S e r v i c e B u l l e t i n

Number: 0007

Title: Cabinet Cooling **Date:** June 9, 2006 (Addendum added March 9, 2007)

Product Identification: PCNC 1100 Milling Machine

Location of wire number 100

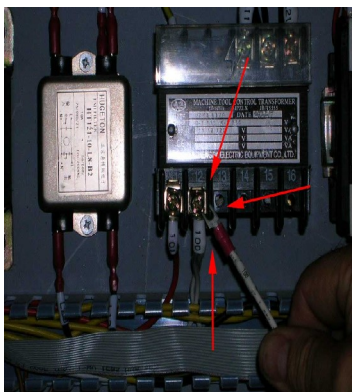
Wire 100 is connected on the control power transformer.
(See addendum, pg 5)

Fan installed

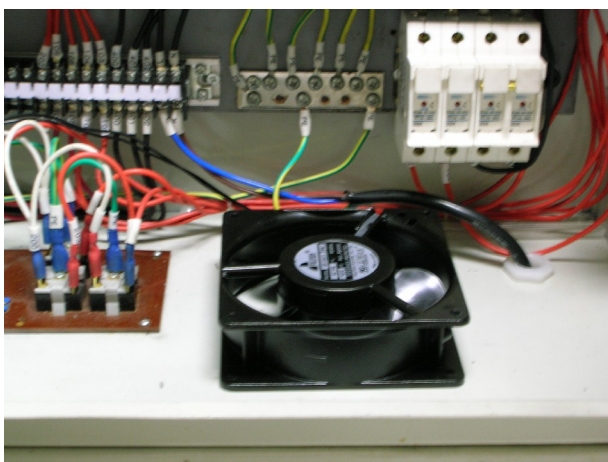
Wire 104 can be connected on a terminal strip which is just above and to the left of the fan.

Make certain that the fan blows into the cabinet. Heat rises allowing the natural convection current to assist the fan in moving the air out of the bottom and out through the top.

ADDENDUM

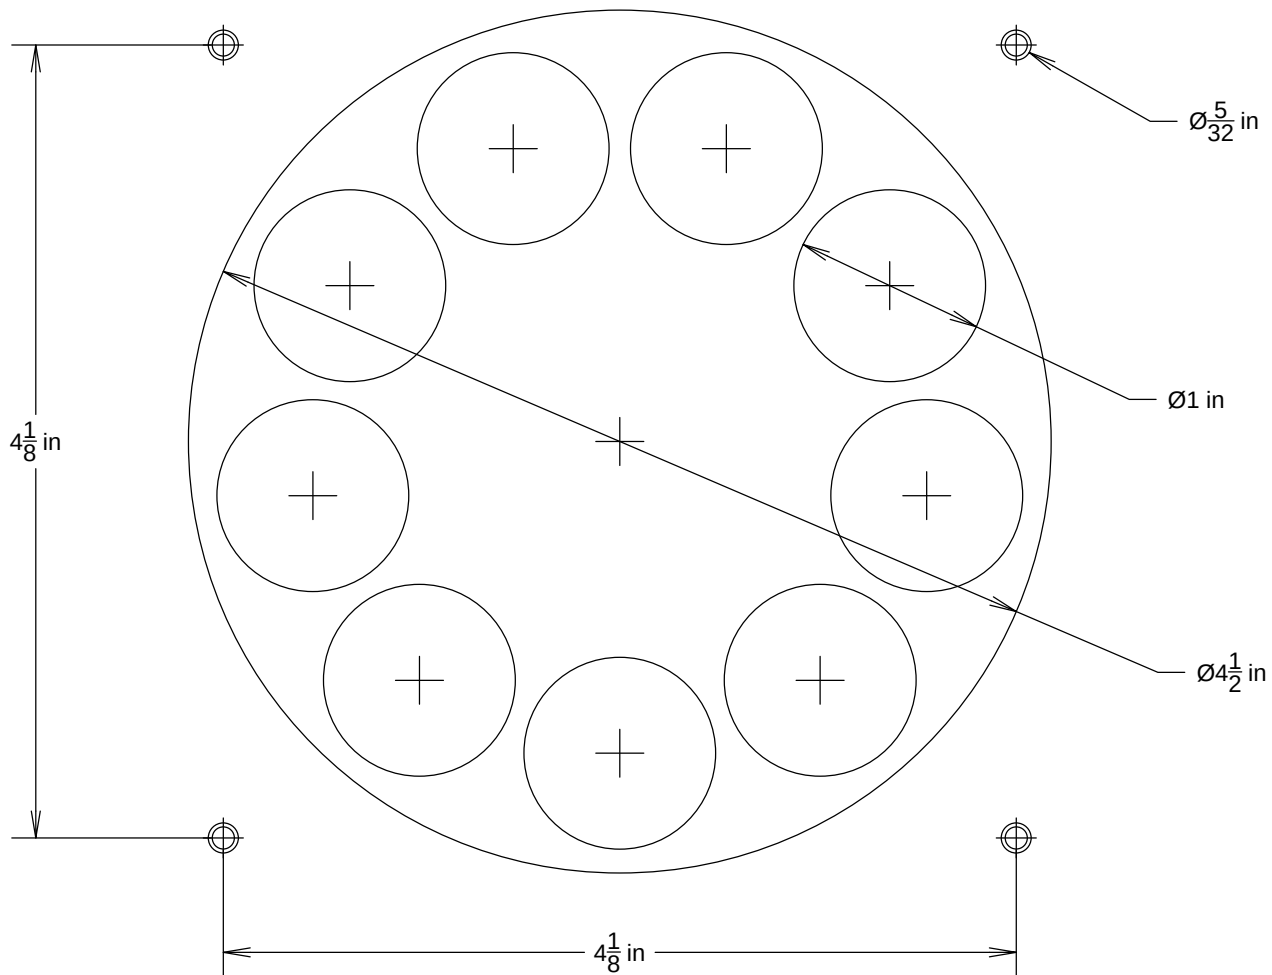
Certain machines do not have wire #104 available on the terminal strip.

All machines will have wire #104 available on the lower right corner of the machine control board (refer to arrow in photo). It will come in on the third terminal from the left. This is terminal J5-3. If #104 is not available on the terminal block then remove wire 104 from J5-3 and connect wire 104 to the terminal block. Use the extra wire enclosed in your kit to connect from the terminal block to J5-3. The end result will then have 3 wires joined at the terminal strip:

1. The 104 that was originally going to J5-3
2. A new 104 that now leads to J5-3
3. The 104 that leads to the cooling fan.
